FRONIUS SUBMISSION - SA GOV CONSULTATION PAPERS

To SA Dept. of Energy & Mining,

Figure 1: Fronius Smart Meeter installed at “feed-in” point

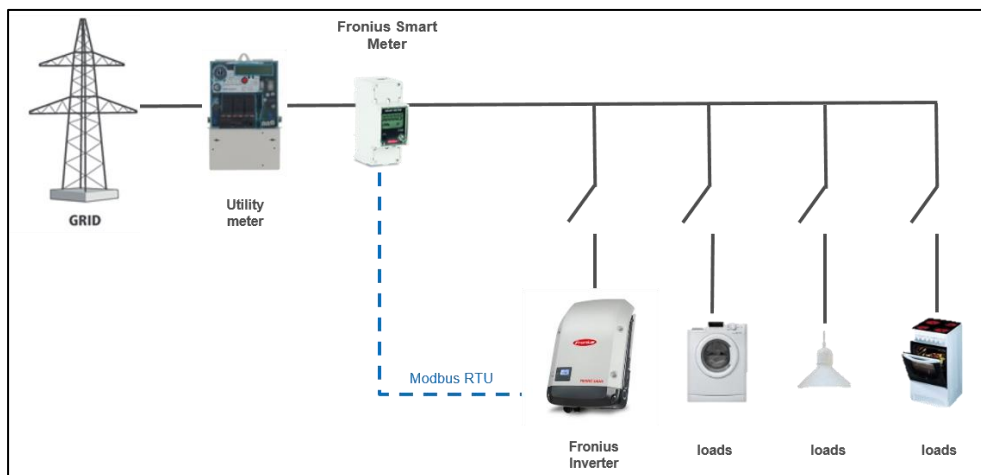
1. Export limiting functionality:

- a. In our export limiting control topology, an energy meter is required to be installed in the “feed-in” path of the customer’s installation i.e. generally directly after the site main switch (see figure 1 below).
- b. Solar & loads must be on the same side of the Fronius energy meter. With the proposed SA smart metering topology, it would no longer be possible to implement an export limited system in South Australia.

Figure 2: EPS Fronius Solution with Fronius Smart Meter installed at “feed-in” point

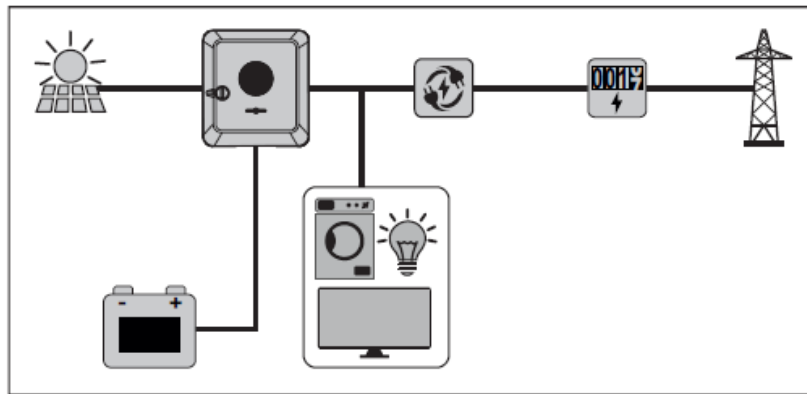
A large percentage of hybrid battery systems being installed are being configured with backup power functionality. In order for this functionality to work our energy meter and a contactor **MUST** be as shown below.

- AC contactor that disconnects the site from the Grid

- Fronius Smart Meter (Energy Meter) and is needed to help detect if the Grid is present

With the proposed new multi-channel smart meter topology this will prohibit any of these types of systems from being installed and preventing customers from having a reliable battery backup system. Below is another example of system topology that will not work (Tesla Powerwall)

Figure 3: Tesla EPS Solution with Tesla Meter installed at “feed-in” point

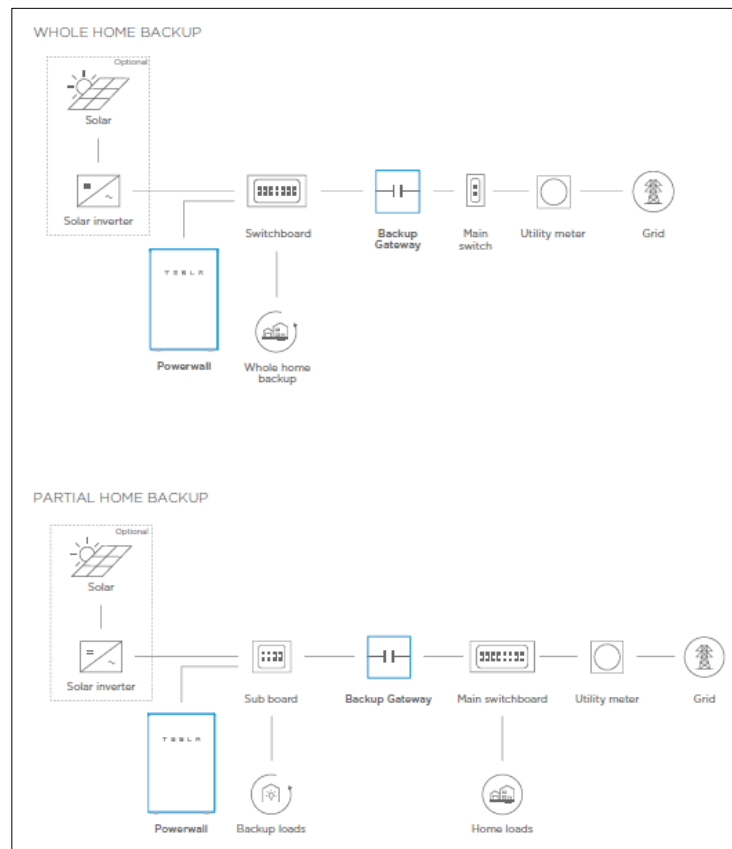
To our knowledge there are no other countries that have this proposed multi-channel meter arrangement.
